<b>Docket Number:</b>	18-BSTD-02
<b>Project Title:</b>	2019 ENERGY CODE COMPLIANCE MANUALS
<b>TN #:</b>	224318
<b>Document Title:</b>	Owens Corning Comments on 2019 Energy Code Compliance Manuals
<b>Description:</b>	N/A
<b>Filer:</b>	System
<b>Organization:</b>	Shawn Mullins
<b>Submitter Role:</b>	Public
<b>Submission Date:</b>	7/27/2018 4:58:43 PM
<b>Docketed Date:</b>	7/30/2018

**Owens Corning Comments on 2019 Energy Code Compliance Manuals**

RE: 2019 Energy Code Compliance Manuals Comments

**Figure 3-43: Unvented Attic Assembly with Insulation at the Ceiling and Between the Roof Rafters**

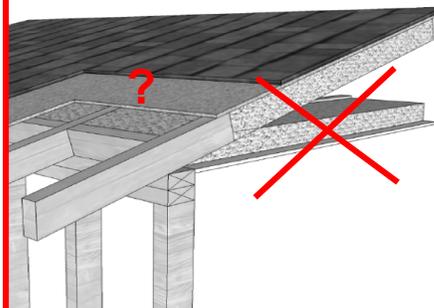
**Concern:** The requirements listed in this section for unvented attics conflict with the 2016 California Residential Code (CRC). The CRC was appropriately revised to be more consistent with the International Residential Code language. See partial excerpts of section 806.5 in the 2016 CRC below. We recommend revising the language and associated diagrams in 3.6.1 to be consistent with the 2016 CRC. We also recommend the Commission NOT adopt any language that would be introducing new

requirements not already enshrined in the building codes, and instead, rely on system evaluation reports for addressing any specific manufacturer system related requirements.

**Figure 3-47:** Insulated Roof Tile (IRT) (A) attached directly to roof deck, (B) attached to batten, (C) attached directly to roof deck with wedged foam filling air space, and (D) attached to battens with wedged foam filling air space

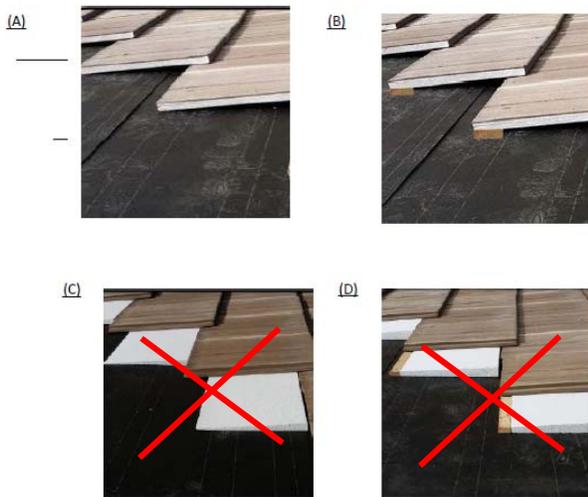
**Concern:** The “wedged insulation” below roofing tiles is an approach that has not been proven to be commercially viable. The manufacturer introduced this concept with market claims which later became very suspect. Delivered R-values are in question as are some of the standards the manufacturer references to claim compliance or equivalency in the code. At this time there does not appear to be any other manufacturers promoting this type of product or application. It is therefore misleading to the larger market and inappropriate for the California Energy Commission to be advocating this particular assembly. Recommend striking these images and the referencing language from this section. Should a better design find its way to the market post publication of these manuals, the performance path would continue to allow for such product(s) to demonstrate code compliance. Leave in the reference to Insulated Roof Tiles as per their proven contribution and commercial viability to applicable sections of the energy code.

Figure 4-16: Buried Ducts on Ceiling and Deeply Buried Ducts

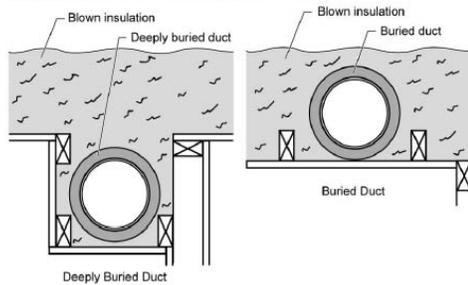
**Concern:** The existing requirements for improving the energy performance of HVAC distribution ducts via burying ducts is antiquated and does not allow for more recent studies showing enhanced performance without having to build soffits to encase the ducts. We recommend consideration be given for deeply buried ducts above the ceiling plane wherein it can be demonstrated that insulation mounds around and on top of the duct can be sufficiently contained so as to deliver sustainable thermal performance. Specifically, we advocate for such systems (where low leakage ducts are also installed) to be given compliance credit equal to, or as close to equal to as can be demonstrated, to ducts in conditioned space. This is similar to the 2018 IRC methodology and modified Home Innovation Research Labs illustration shown above.
